FINAL PHASE I
CONTAMINATION ASSESSMENT REPORT
SECTION 27: NONSOURCE AREA
(Version 3.1)

December 1987 Contract Number DAAK11-84-D0016 Task Number 14 (Army Sites North)

APPENDIX 27-UNC-C COMMENTS AND RESPONSES

# RESPONSE TO SPECIFIC COMMENTS OF THE U.S. ENVIRONMENTAL PROTECTION AGENCY ON THE DRAFT FINAL TASK 14 REPORT SECTION 27: NONSOURCE AREA

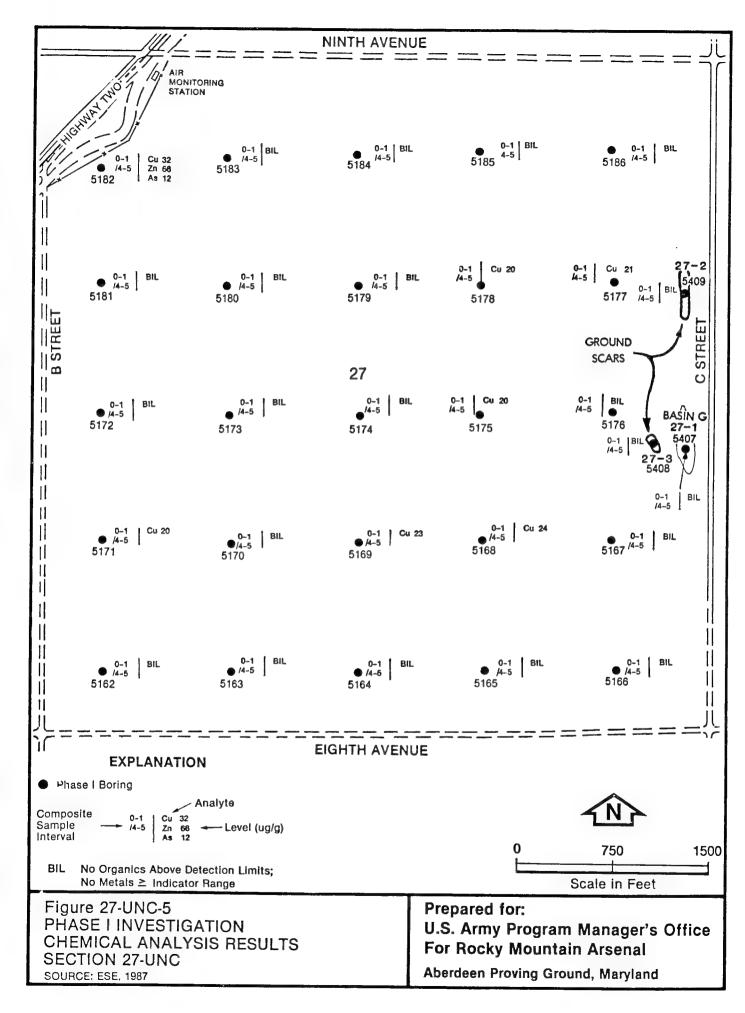
<u>Comment 3:</u> p. 27-UNC-18

Response:
